Prescot to Cronton

Road Safety Audit Designer's Response

Project number: 60629784
60629784-REP-30-PC-CT-0014

Drawing: 60629784-SHT-30-PCP1-CT-0101

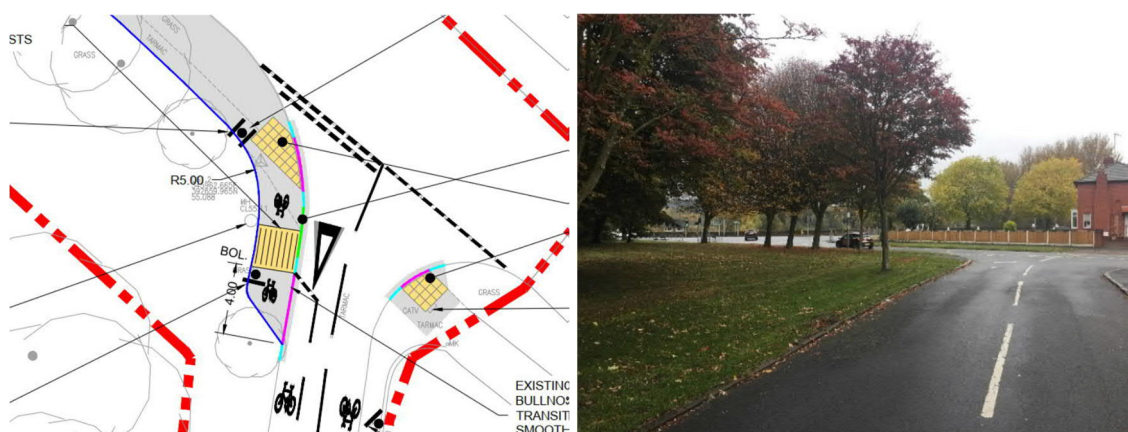
Summary: Risk of injury to pedestrians and cyclists due to proposed location of cycle transition point to / from the shared use area at the Manchester Road / South Avenue junction.

Description: Drawing 60629784-SHT-30-PCP1-CT-0101 shows the General Arrangement of the proposed scheme, including the location of dropped kerbs to allow cycle transition to / from the shared use footway / cycleway at the north west corner of the Manchester Road / South Avenue junction. Due to the proposed location, it is anticipated that cyclists travelling north and south on South Avenue will be expected to use the transition point to continue their journey on the shared use route on Manchester Road (west).

The location of the dropped kerbs is such that a cyclist approaching from the northwest, travelling along the shared use footway / cycleway towards South Avenue, will need to look behind them to check if a motorist is turning right from Manchester Road to South Avenue. They will also need to check if a motorist is turning left from Manchester Road to South Avenue, and if a cyclist is turning from South Avenue onto the shared use route. In addition to this, they will also have to negotiate pedestrians using the shared use route.

The Audit Team has concern due to the level of possible conflicts at the cycle transition point, particularly as cyclists will need to look behind them to join South Avenue. The design may result in collisions between pedestrians and cyclist and / or cycles and turning vehicles.

It is recommended that separate pedestrian and cycle routes are provided, utilising the area of landscaping to the south of Manchester Road, west of South Avenue. Alternatively, it is recommended that the cycle transition point is relocated to minimise the risk of conflict between pedestrian, cyclists and road users identified.

The landscaping mentioned in the audit recommendation is not in KMBC's ownership and was not available for use during the design stage.

Ideally the routes for pedestrians and cyclists would be separated all along Manchester Road but this was not feasible as part of this scheme due to land ownership and tree removal would be needed.

When the design for this area was undertaken, safety and potential conflict was considered throughout. Such items were implemented to mitigate risks:

- Implementing buff tactile paving on either side of the crossing for pedestrians to be more DDA compliant and a benefit to the scheme and the overall area.

- The cycle transition on and off the carriageway was brought away from the bellmouth so that cyclists would not conflict with vehicles waiting at the give way.

- The cycle transition on and off the carriageway was brought away from the bellmouth so drivers have better visibility of cyclists as they are transitioning on and off the carriageway.

- The cycle transition on and off the carriageway was brought away from the bellmouth so that cyclists were transitioning away from the actual junction.

- A good length of cyclist transition with appropriate tactile paving and cycle marking symbols incorporated to designate the different provisions around the junction. The area also has good visibility so it is thought that pedestrians using the shared use route and wanting to cross from the east will be able to see approaching cyclists from all directions.

Problem 3.3.3

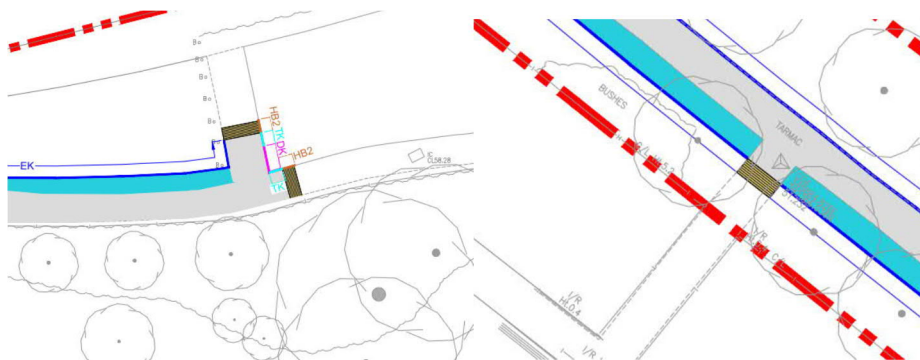
Summary: Risk of injury to pedestrians and cyclists resulting from collisions due to shallow depth of buff.

Description: Throughout the extents of Phases 1, 2 and 6, buff coloured warning corduroy tactile paving is proposed at various locations, to delineate the start and end of the shared use routes. Corduroy paving should be used where visually impaired people need to be warned of a hazard and advised to proceed with caution, such as where a footway joins a shared use route.

In some locations, the depth of the paving looks to be too shallow. As such, there is a risk that visually impaired pedestrians approaching the shared use route in a direct line, may overstep the buff coloured warning corduroy tactile and in doing so, not realise the possibility of cyclists within the (shared) footway. This may lead to collisions, causing injury to pedestrians and cyclists.

It is recommended that buff coloured warning corduroy tactile paving is provided in accordance with latest design standards, to delineate the start and end of the shared use route.

Designer's Response	☐ Accepted ☒ Part Accepted ☐ Rejected
Depth of the corduroy paving is to be 800mm in accordance with “Guidance on the use of Tactile Paving Surfaces”, as shown in the below figure, corduroy is supposed to be 800mm when there is a change to shared use designation:

The 2400 dimensions (shown in the above extract) is in relation to tramline and ladder paving which is to be used for segregated cycle and pedestrian routes and is therefore not applicable for shared use routes.

Drawing: 60629784-SHT-30-PCP6-CT-0101

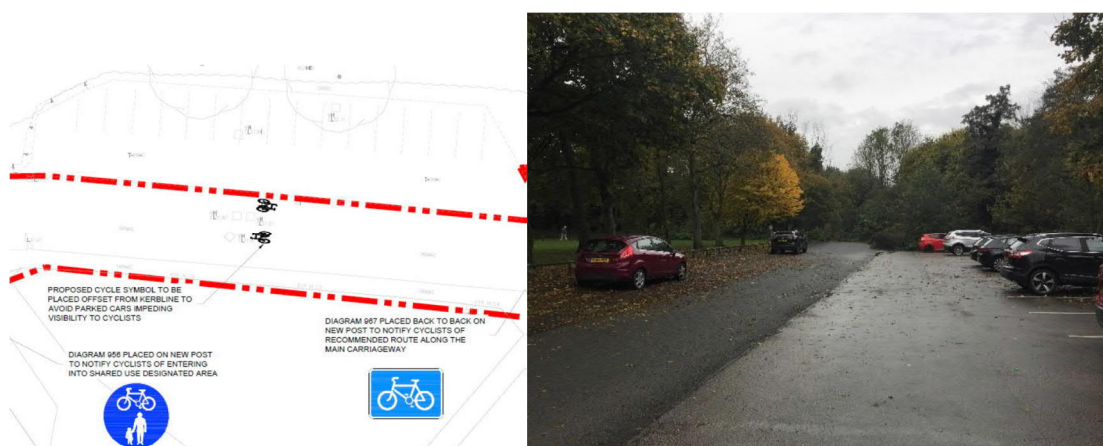
Summary: Risk of injury to cyclists resulting from collisions with vehicles as motorists enter / exit parking bays in the Stadt Moers Park car parking, due to the alignment of the proposed cycle route.

Description: The Stadt Moers Park car park is accessed via Pottery Lane. Parking bays align the northern edge of the car park and parking activity also takes place along the southern kerb edge, although parking bays are not provided. Drawing 60629784-SHT-30-PCP6-CT-0101 shows the proposed route cyclists are encouraged to use to travel through the Stadt Moers Park car park. The eastbound route passes directly behind the parking bays to the north.

On site observations suggest that drivers drive into the parking bays, therefore requiring them to reverse out when leaving. Due to this observation and the alignment of the cycle route, as a driver exits from the parking bay, there is a risk that they may not have full visibility of a cyclist passing behind them. This may result in a collision, potentially causing an injury.

This is a quiet road for parking only and drivers should be aware (due to the new signage and road markings provided) of the close proximity to cyclists and walkers using the area. The road markings showing the cycle symbol have been purposely offset from the kerb line so that they can still be seen when vehicles are parked along it.

For the parking bays (shown on the right in the photo above), when cyclists are using the main stretch (dark grey pavement in photo), there is still sufficient space for vehicles to manoeuvre out of the parking space (using the lighter grey pavement extents) without encroaching into the path of cyclists.

Drawing: 60629784-SHT-30-PCP6-CT-0101

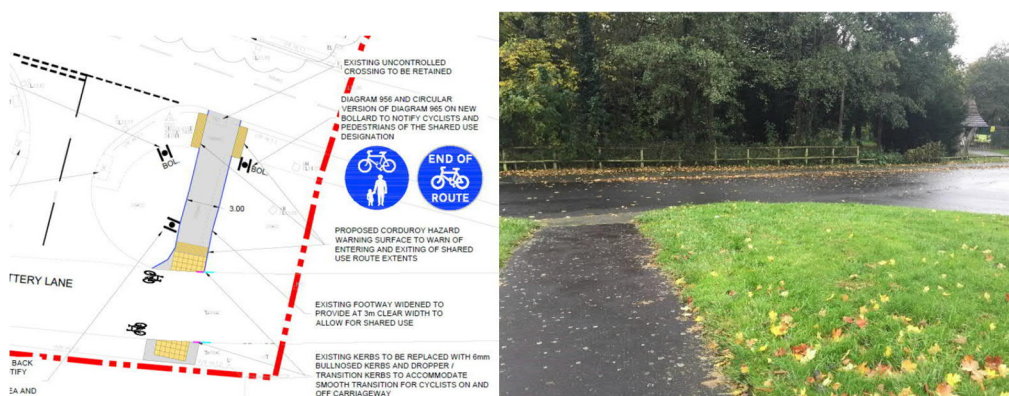
Summary: Risk of injury to pedestrians and cyclists resulting from collisions within the proposed shared use area between Pottery Lane and the Stadt Moers Park car park, due to confusing access arrangement.

Description: The Stadt Moers Park car park is accessed via Pottery Lane. Pedestrian access is provided by a footway that extends through a grass verge area, between the northern and southern alignment of Pottery Lane. The proposed design, as shown on General Arrangement drawing 60629784-SHT-30-PCP6-CT-0101, includes measures to widen the footway to accommodate shared use, plus the provision of both corduroy and blister tactile paving to delineate the shared use route and uncontrolled crossing.

From a review of the information provided, cyclists will enter and exit the shared use section of footway / cycleway via a dropped kerb at the southern extent of the footway. In this same location, pedestrians will cross Pottery Lane as they enter / exit the Stadt Moers Park car park.

The Audit Team has concern due to the level of possible conflicts at the cycle transition point. Conflicts between cyclists and pedestrians may lead to collisions, potentially resulting in injury.

It is recommended that separate pedestrian and cycle routes are provided, removing the risk of conflicts between pedestrians and cyclists.

The design allows for a shared use route in the north / south direction while also maintaining the existing footways / footpaths around the area. This means that pedestrians can choose to use the pedestrian only footways / footpaths should they not want to use the shared use space.

In regard to the potential conflict with pedestrians heading east / west on the southern side with cyclists, corduroy paving has been placed on the newly widened section of hard standing, before the buff blister paving, indicating to users that they are leaving the shared use extents. This means that pedestrians can continue to cross Pottery Lane onto the existing southern footway but cyclists are to use the crossing to join the carriageway only. Therefore, conflict between pedestrians and cyclists should be limited/low risk.

Drawing: Several

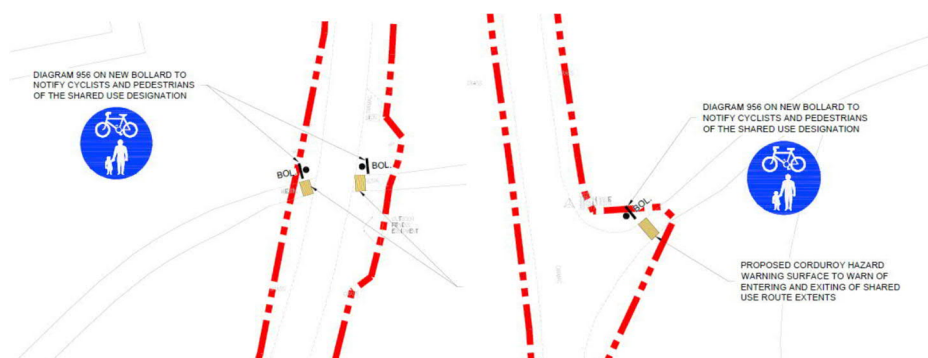
Summary: Inconsistent use of 'End of Route' signs between Phases 1 and 2 and Phase 6 may result in collisions between pedestrians and cyclists, as cyclists continue their journey on a pedestrian only route. Additional risk of fall related injuries due to unsuitable condition of terrain.

Description: Throughout Phases 1 and 2, there are locations where 'End of Cycle Route' signs (dia. 965) and shared use signs (dia. 956) are provided, to notify pedestrians and cyclists of the start and end of the shared use route. At several intersection points through Phase 6, the 'End of Cycle Route' sign has not been provided, however buff coloured warning corduroy tactile paving is, to delineate the start and end of the shared use route.

Without the 'End of Cycle Route' signs in place, cyclists may not realise that the route becomes pedestrian only at locations along the length of Phase 6. In doing so, there is risk that cyclists will attempt to continue their journey along pedestrian only routes, into the path of pedestrians. Should this happen, there is a risk of collisions, resulting in injury. Furthermore, there is a risk that the terrain along the pedestrian only routes is unstable or unsuitable for cyclists. If so, there is a risk of fall related incidents occurring for cyclists.

It is recommended that a consistent approach is adopted and where 'End of Cycle Route' signs (dia. 965) are provided at all locations where the cycle route terminates to avoid cyclists colliding with pedestrians along footpath facility.

It was agreed with the client that the 'End of Route' signs would be incorporated for all aspects of the scheme apart from those phases which run through the parks / green areas (i.e. Phase 5 and 6).

The 'End of Route' signs have been implemented when the shared use designation finishes and it moves back to footway / footpath within the adopted highway extents.

Through the open spaces / parks, the end of route was omitted because the paths which led away from the shared use route are all narrow and therefore do not make it possible to be shared use. Therefore, it was deemed sufficient that the corduroy paving, which has been implemented on each of the side paths, would be all that was required.

Drawing: 60629784-SHT-30-PCP8-CT-0113

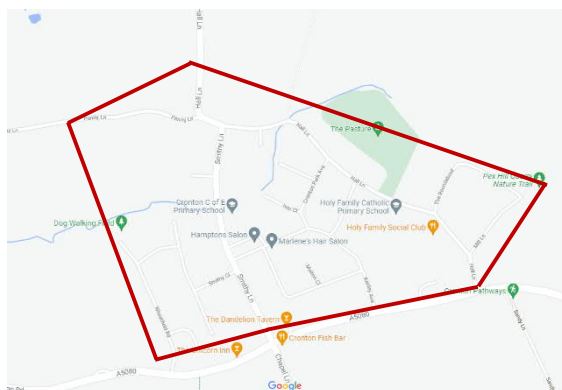
Summary: Risk of cyclists / pedestrians / vehicle collisions because of observed vehicle speeds.

Description: Drawing 60629784-SHT-30-PCP8-CT-0113 shows the proposed on carriageway cycle route along Hall Lane and Penny Lane. During the site inspection the Audit Team noted that vehicle speeds on the approach to this junction were high and evidence of collisions was also noted.

The Audit Team has concerns that should vehicle speeds remain high in the vicinity of this junction, there may be an increased risk of pedestrian / cycle / vehicle collisions once the scheme has been implemented and this is a promoted pedestrian and cycle route.

It is recommended traffic calming measures are implemented on Hall Lane and Penny Lane to reduce traffic speeds.

Penny Lane and Hall Lane, to the north of the junction, are narrow country lanes where vehicle must slow to pass. There is already a 20mph limit on the approach to the junction with 'SLOW' and '20' road markings. The proposals allow for the renewal of the existing 20mph roundel road mark on Penny Lane. Hall Lane & Smithy Lane, to the east, are also 20mph zones. The area is close to a village with narrow roads requiring oncoming traffic to give-way to allow passing and 20mph areas through-out, so the likelihood of high-speed traffic is low. The plan below shows the extent of the 20mph zone.

As well as the renewal of the existing road markings in the area, an additional 20mph roundel has been incorporated on Penny Lane further in advance of the approach to the junction. This should give further indication to drivers that they need to slow down.

Drawing: 60629784-SHT-30-PCP3-CT-0101

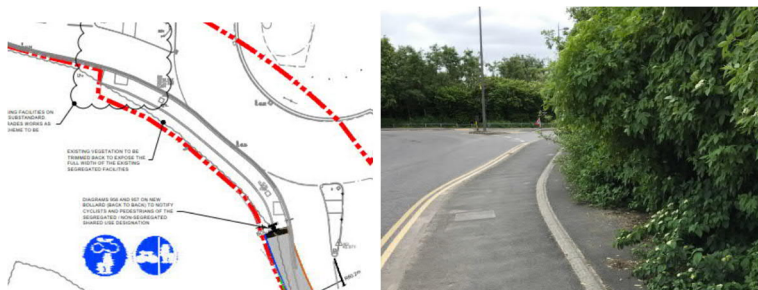
Summary: Risk of pedestrian / cycle collisions as a result of overgrown vegetation affecting segregated route width.

Description: Drawing 60629784-SHT-30-PCP3-CT-0101 shows the proposed cycle route along Prescot Park Way which ties into the existing segregated pedestrian / cycle footway on the western side of the roundabout.

During the site inspection, the Audit Team noted that the vegetation adjacent to the existing segregated facility was overgrown and significantly reducing its effective width.

The Audit Team has concerns that the reduction in effective width of this facility may increase the risk of pedestrian / cycle collisions, should cycles enter the pedestrian only area.

Designer's Response	☒ Accepted ☐ Part Accepted ☐ Rejected
Agreed – The design proposals always allowed for this existing vegetation to be cut back to offer the full effective width of the existing segregated facilities.	
Client Organisation Comments	
This area will be added to the council's areas of maintenance required and the vegetation will be maintained so that it does not protrude onto the newly exposed hardstanding.

Drawing: 60629784-SHT-30-PCP4-CT-0101

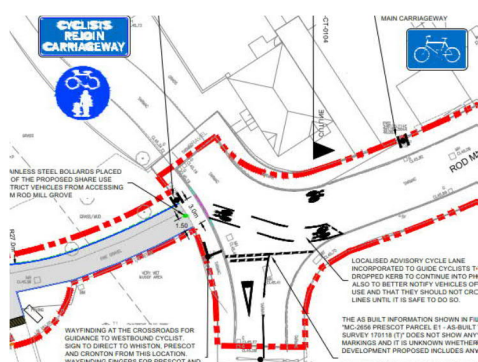
Description: Drawing 60629784-SHT-30-PCP4-CT-0101 shows the proposed on carriageway cycle route along Rod Mill Grove which links into the proposed off carriageway route to the west. Westbound cycles are guided to the shared use footway via an advisory cycle lane at the western end of Rod Mill Grove.

Drawing: 60629784-SHT-30-PCP5-CT-0101

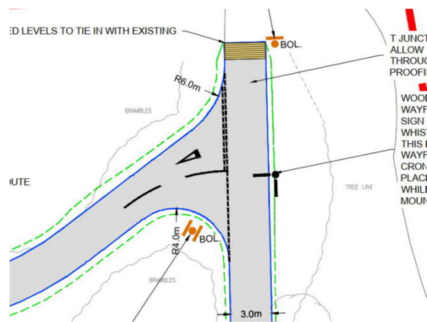
Description: Drawing 60629784-SHT-30-PCP5-CT-0101 shows the proposed off carriageway shared use cycle / footway. The proposed design includes a priority-controlled arrangement between the north / south route and the east / west route.

It is recommended the 'Give Way' markings are omitted, and the alignment revised to suit the need of all users.

Designer's Response ☐ Accepted ☒ Part Accepted ☐ Rejected

Drawing: 60629784-SHT-30-PCP8-CT-0102, 0103, 0104, 0105

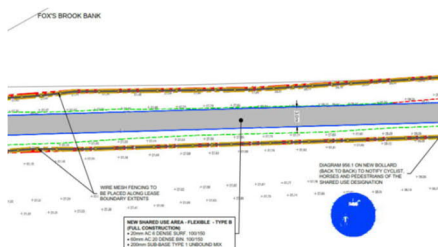
Description: Drawings 60629784-SHT-30-PCP8-CT-0102, 0103, 0104, and 0105 show the proposed multiuser route through an existing green field site connecting Penny Lane with the proposed Pegasus crossing on Fox Bank Lane. During the site inspection the Audit Team noted that vegetation adjacent to the proposed path is overgrown.

Designer's Response	☒ Accepted	☐ Part Accepted	☐ Rejected
---------------------	--	--	-----------------------------------

This area will be added to the council's areas of maintenance required and the vegetation will be maintained so that it does not protrude on to the newly exposed hardstanding.

Drawing: 60629784-SHT-30-PCP8-CT-0102, 0103, 0104, 0105

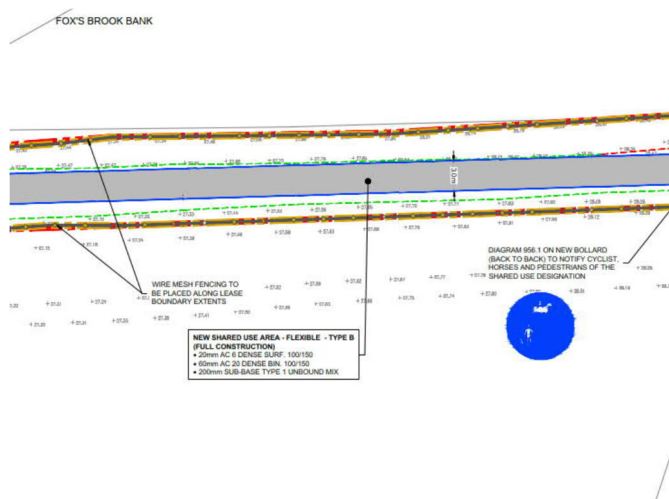
Description: Drawings 60629784-SHT-30-PCP8-CT-0102, 0103, 0104, and 0105 show the proposed multiuser route through an existing green field site connecting Penny Lane with the proposed Pegasus crossing on Fox Bank Lane. During the site inspection the Audit Team noted that there is a deep drainage ditch on the northern side of the green field site running adjacent to the proposed multiuser path.

The information provided to the Audit Team does not show any proposed fencing or similar measure, to prevent access into the drainage ditch. The Audit Team has concerns that without protection, there may be an increased risk that pedestrians / cyclist / horse riders may inadvertently enter the ditch, resulting in injury.

The note pointing to the red and yellow line in the image above and in the drawings, references a wire mesh fence to be incorporated. This fence will be installed on both sides of the route and therefore will provide containment for users to the available extents of the

Drawing: 60629784-SHT-30-PCP8-CT-0110, 0111, 0112

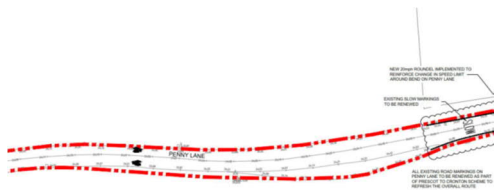
Description: Drawings 60629784-SHT-30-PCP8-CT-0110, 0111 and 0112 show the proposed on carriageway cycle route along Penny Lane. The proposed works include 'Quiet Street' cycle markings along Penny Lane at regular intervals. Penny Lane is subject to National Speed limit and on-site observations made by the Audit Team indicated that vehicle speeds are perceived to be high.

We consider this type of road to be in line with other typical rural road environments, some of which have national cycle routes associated with them. Some that are known to us are more of a risk of conflict because Penny Lane offers much better forward visibility.

Drawing: 60629784-SHT-30-PCP9-CT-0108

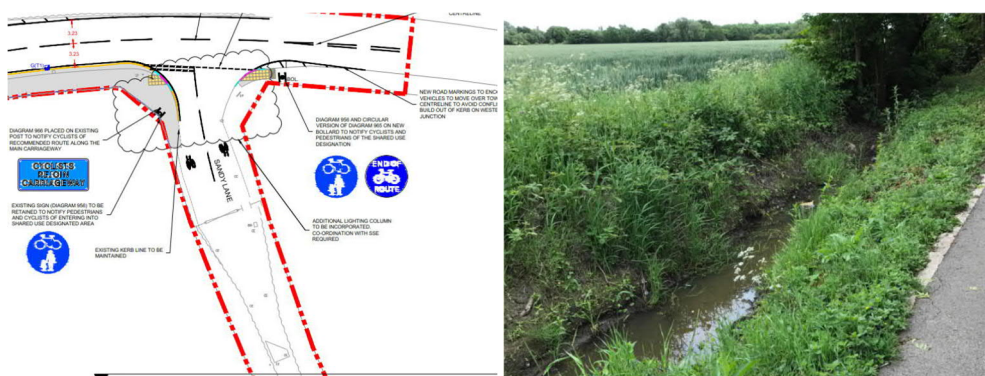
Description: Drawing 60629784-SHT-30-PCP9-CT-0108 shows the proposed pedestrian cycle route running along the existing alignment of Sandy Lane. During the site inspection the Audit Team noted that deep drainage channels extend along both sides of Sandy Lane, adjacent to the proposed pedestrian / cycle path. The information provided to the Audit Team does not show any proposed fencing or similar measure to prevent access into the drainage channels.

Drawing: Various

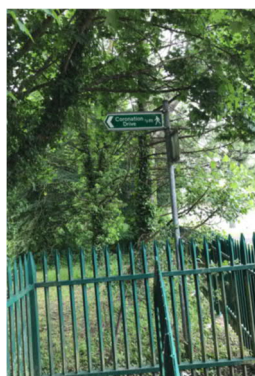
The Audit Team has concerns that without the correct wayfinding signing to direct cycles and pedestrians along the propose route there may be an increased risk of users deviating from the proposed route potentially increasing the risk of pedestrian / cycle collisions.

It is recommended a revised wayfinding signing strategy is provided for the proposed cycle and pedestrian route.
